Rezoning Transportation Analysis

Petition Number: 2026-037

General Location Identifier: 06906619, 06906620, 06906621, 06906623, 06906624

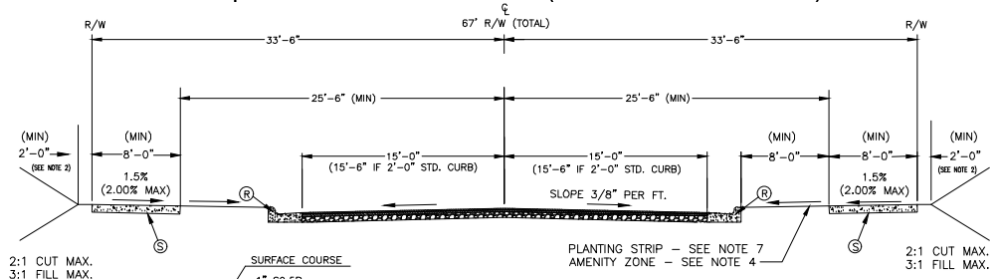
- b. ~~Sanders Avenue: Location of future back of curb and gutter needs is 17.5' from centerline and the future location of curb and gutter is in its existing location.~~

~~CLDSM standard per Table 33-2 in article 33 (and meets condition 3): Residential Wide U-04A.~~

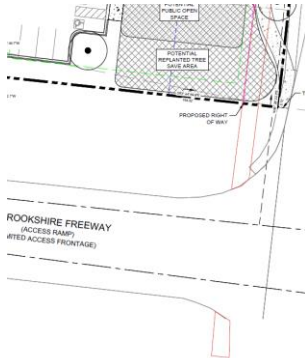
9. ~~CDOT REQUEST: Revise site plan and conditional note(s) to commit to extending the sidewalk to the W. Brookshire Freeway and reconstructing ramps on both sides. This will assist in better and safer pedestrian facilities and assist in the city's Vision Zero efforts. NCDOT maintains W. Brookshire Freeway and have stated they would not have an issue with this adjustment.~~

Update 7-23-26: Petitioner has stated "Unfortunately, we are unable to commit to the request".
